**Item 12.****Development Application: 22 O'Riordan Street, Alexandria - D/2019/686**

File No.: D/2019/686

**Summary**

**Figure 33:** Site plan depicting land dedication

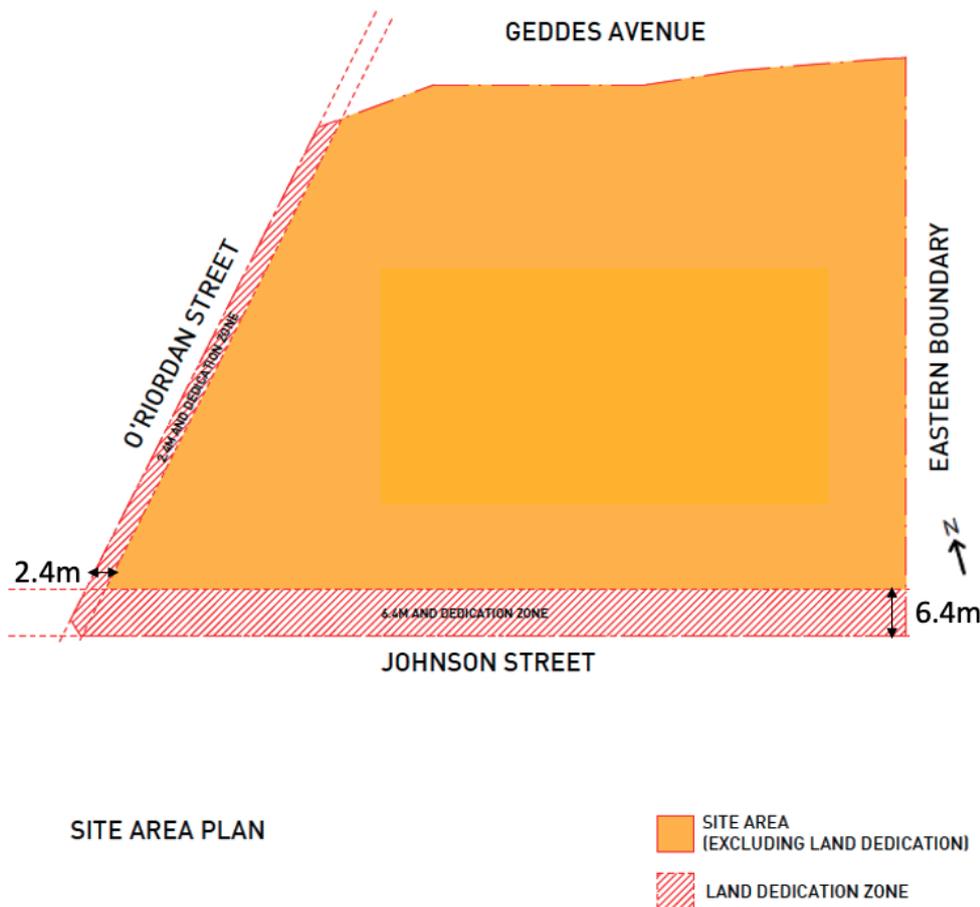
44. Section 5.8.2.2 (Southern Employment Lands) of the Sydney DCP 2012 identifies 2.4m footpath widening along O'Riordan Street, and 6.4m landscaped setback along Johnson Street, along two of the site's street frontages.

45. A public benefit offer has been submitted with the application. A draft VPA has been prepared based on this offer in relation to the proposal and includes the following public benefits:
- (a) Dedication and associated construction of land along the O’Riordan Street frontage of the site for footpath widening. The piece of land is approximately 2.4m wide, with an area of 199sqm as shown in Figure 33 below.
  - (b) Dedication and associated landscaping works of land along the Johnson Street frontage of the site for footpath widening. The piece of land is approximately 1.4m wide and 686sqm in total.
  - (c) A monetary contribution of \$1,487,000 towards community infrastructure.

**Figure 35:** Proposed deep soil zone plan and land dedication

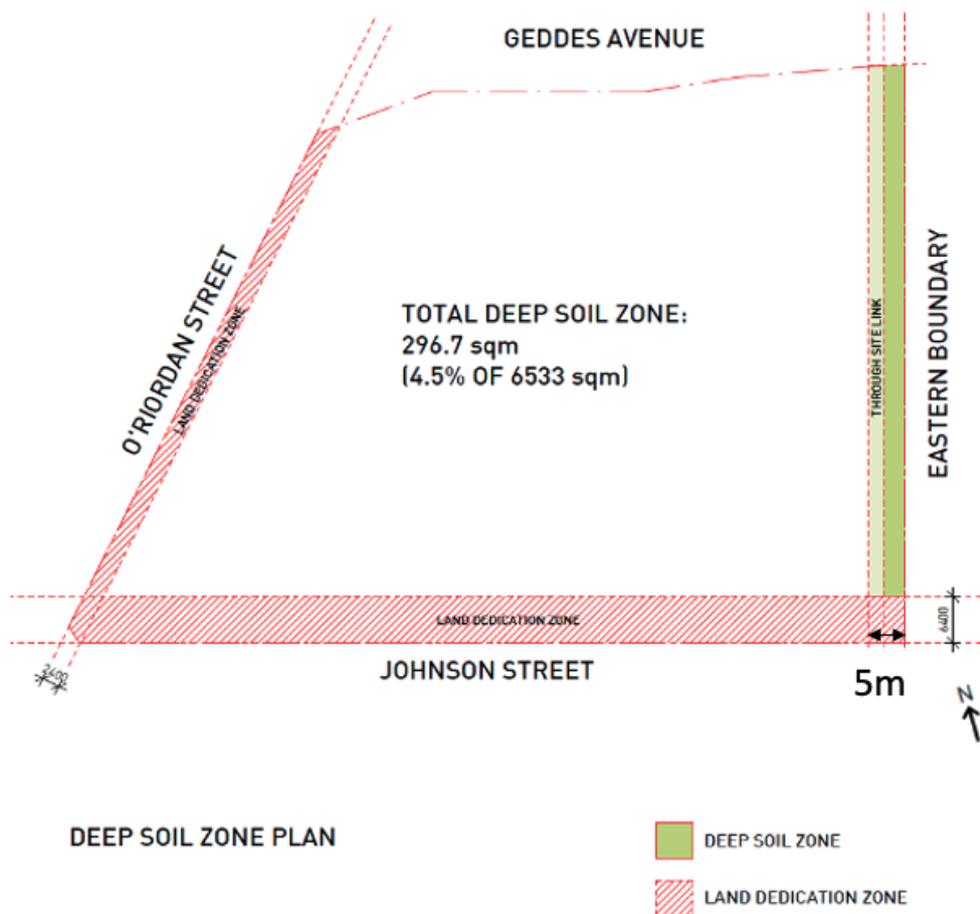
- 54. Section 5.8.2.5.1 of the Sydney DCP 2012 stipulates that 10% of the site area is required to contain deep soil landscaping. The minimum dimension for deep soil is 3m in any direction. Based on a reduced site area (minus land dedication) of 6,533sqm, 10% is 653.2sqm

- 55. The application proposes a deep soil zone equal to 296.7sqm, or 4.5% to the eastern boundary of the site via the provision of a through-site link. The through-site link is to be 5m in width, be open to the public, and will be under private ownership.

- 56. The applicant has proposed a through-site link to provide a connection between the new Geddes Avenue extension and Johnson Street, giving occupants of the new development an opportunity for breakout space, as well as a shortcut for pedestrians utilising Botany Road or O'Riordan Street. Whilst the DCP does not require a through-site link in this location, it is also considered beneficial in light of the three sites to Botany Road being unlikely to consolidate to provide a through-site link of their own.

- 57. See figure 35 below depicting the proposed deep soil zone and land dedication.

58. As discussed elsewhere in this report, the applicant is required to dedicate approximately 884sqm to the City, 686sqm of which is to become landscaped area to Johnson Street. This landscaped area, combined with the proposed deep soil zone provides 982.7sqm or 15% of deep soil.
59. Due to the large dedication of site area to the City for landscaping purposes, it is considered reasonable to support a variation to this control.
60. A condition of consent is recommended requiring the provision of at least 296.7sqm (4.5% of the site) as deep soil, as demonstrated in the proposed building envelope drawings. The applicant will also be required to create an easement on title to allow for public access to the through-site link.
